Project Name: UNIVERSITY OF CALIFORNIA, MERCED

KOLLIGIAN LIBRARY 3W RENOVATION

ADDENDUM NO. 1

July 20, 2018

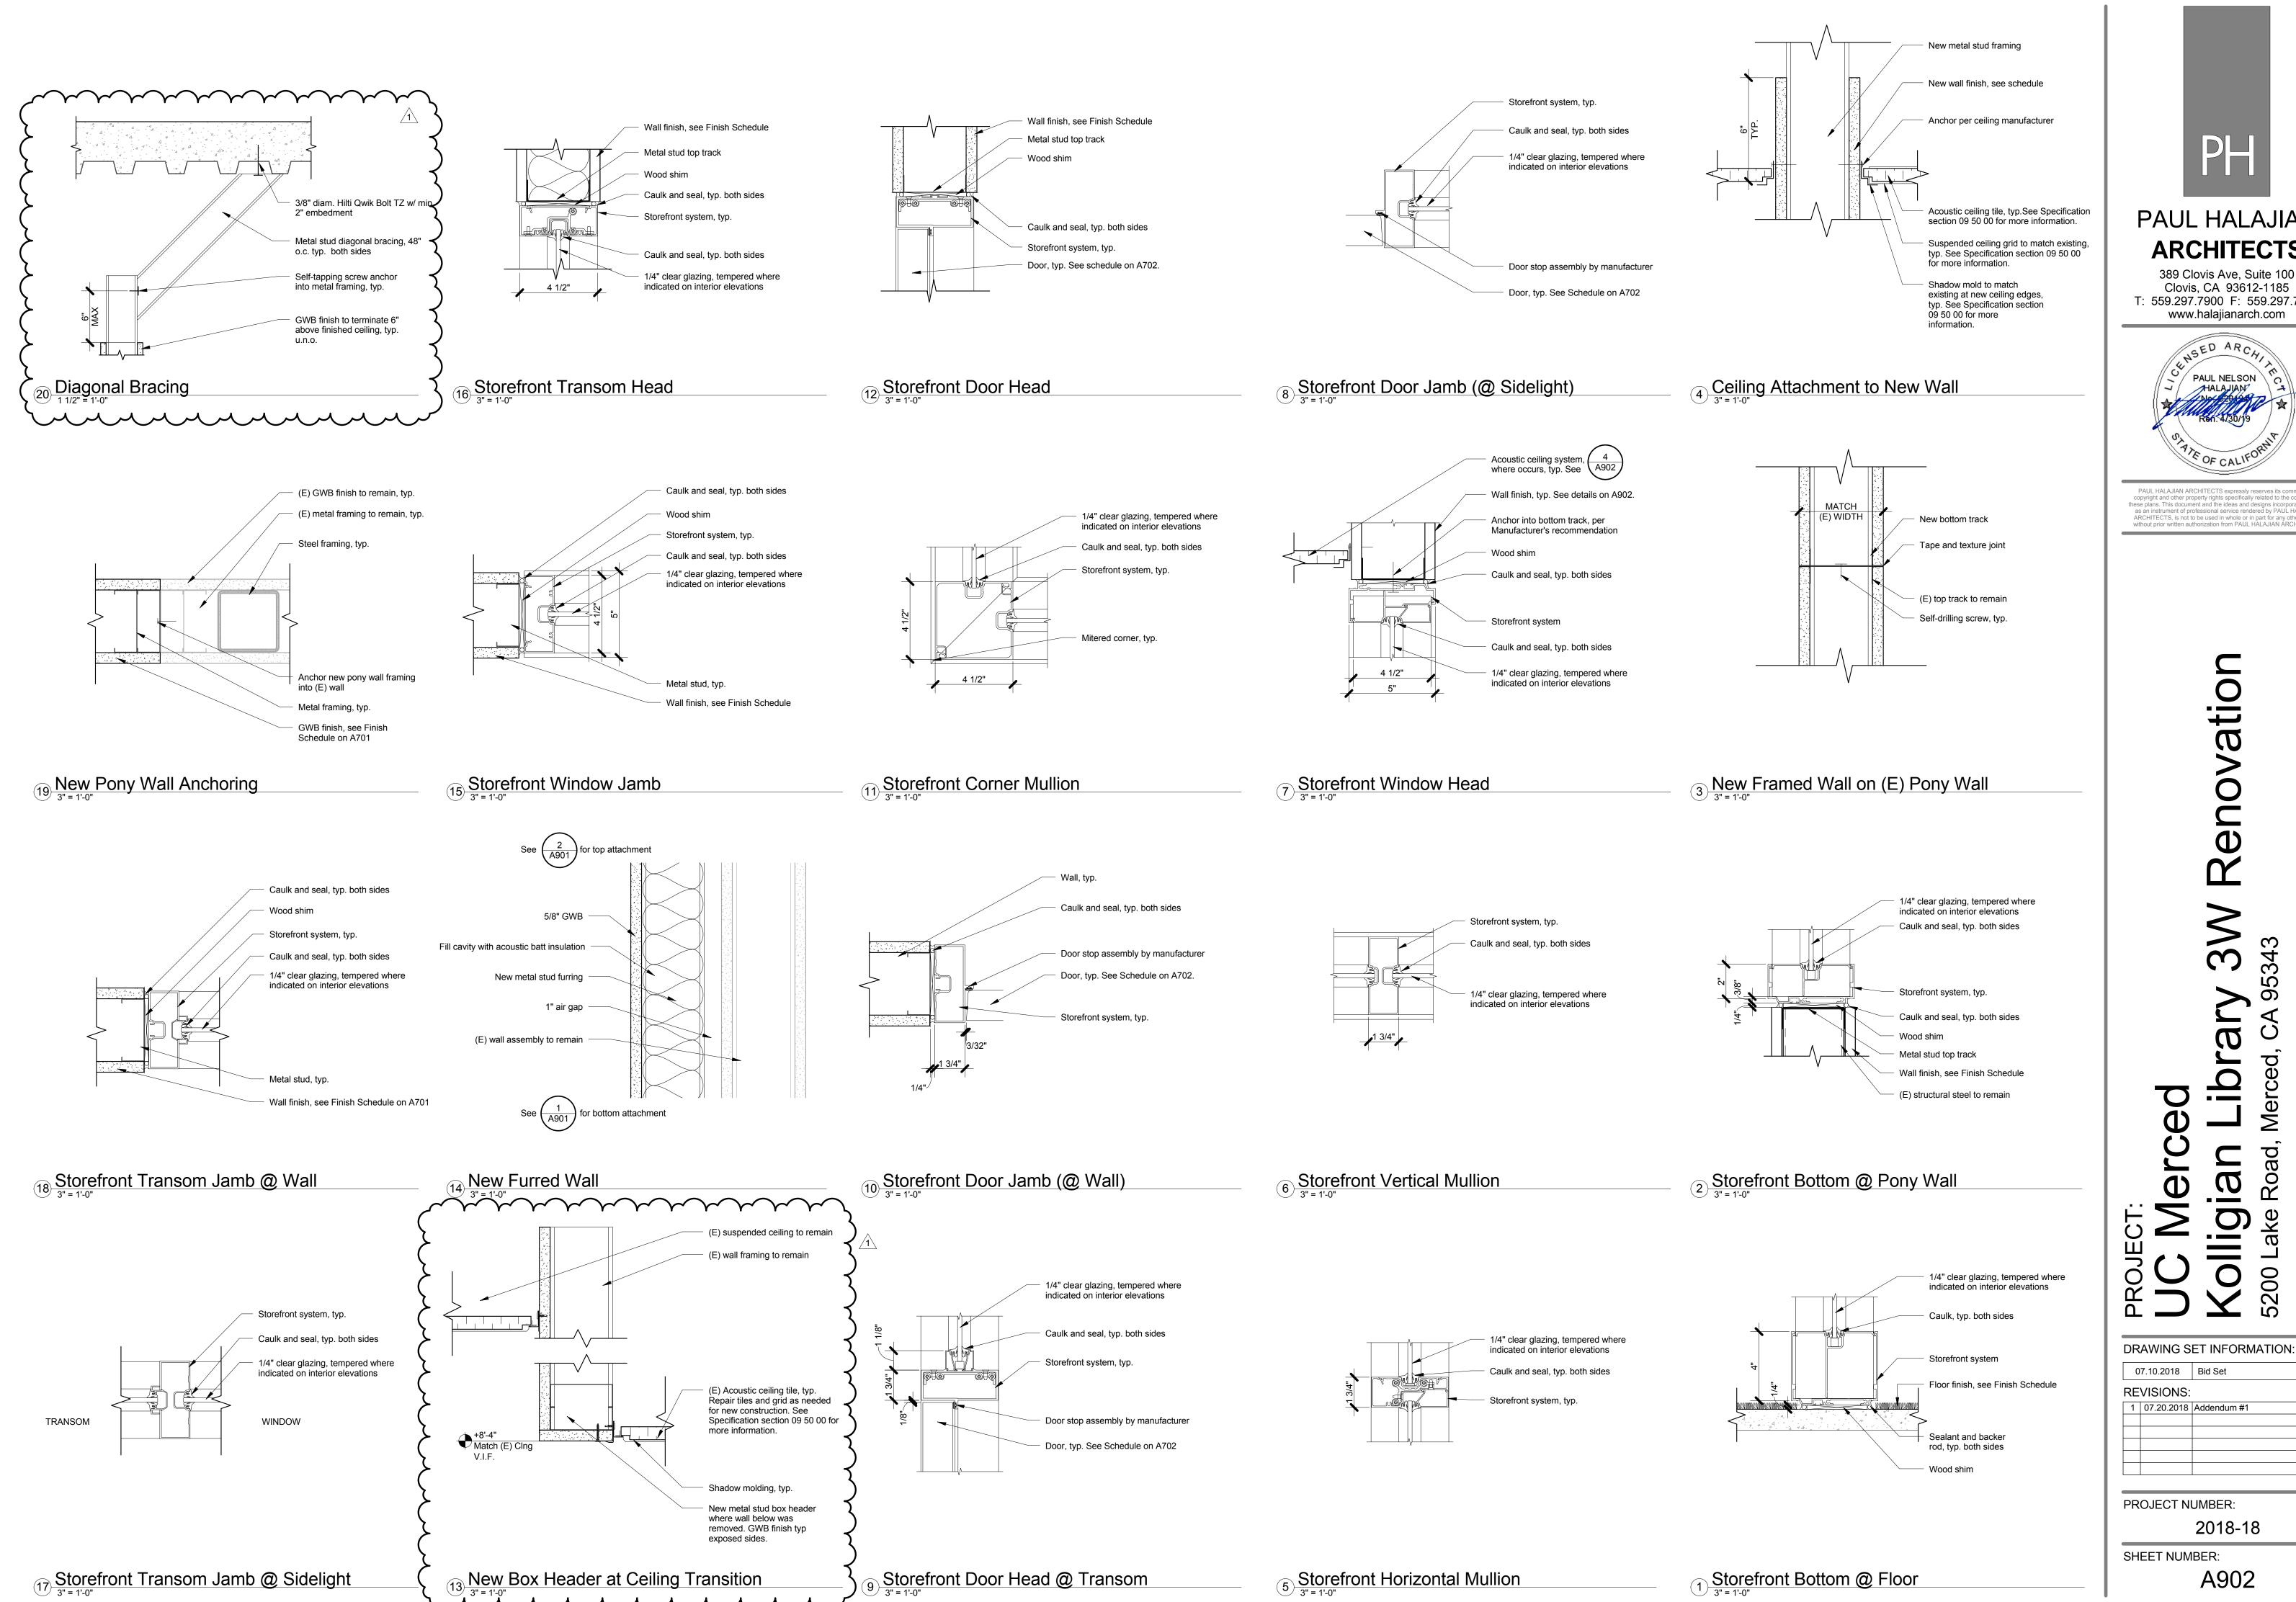
- A. PRE-BID QUESTIONS Questions received from bidders and responses are as follows:
 - 1. Q. Wall #2 on D201 due to two different ceiling heights, once the wall is removed, will there be a box beam header installed? If so, please advise the detail for the "box header" including support and attachment above and at each end. Can a "T- Bar" transition be installed there? Suspended panel ceiling in that area would easily be supported by a compression strut and brace wires as shown on details 18 & 10 on A901

- A. Detail 13/A902 addresses the difference in ceiling heights.
 - 2. Q. The drawings call for the new walls to be "full height". There are a few locations such as 338 Tutoring West Wall, that have parallel fire sprinkler lines that will not allow the wall to reach the upper deck. Would walls that rise 4" to 6"above the drop ceiling with diagonal bracing be acceptable in non-fire rated areas?

- 9. Item 01-09
 - a. Reference: A201, A802
 - b. Dimensions added for clarity. No change in scope, clarification only.
- 10. Item 01-10
 - a. Reference: A601, 13/A902

- b. Add metal stud box header where wall was removed. See detail 13/A902.
- 11. Item 01-11
 - a. Reference: A201, A401, 2/A901, 20/A902
 - b. Change full height studs to partial height with diagonal bracing per details 2/A901, 20/A902

- A. Detail 20/A902 addresses revised height of framed walls. Newly framed walls, per revised details do not go to underside of deck, they will be diagonally braced.
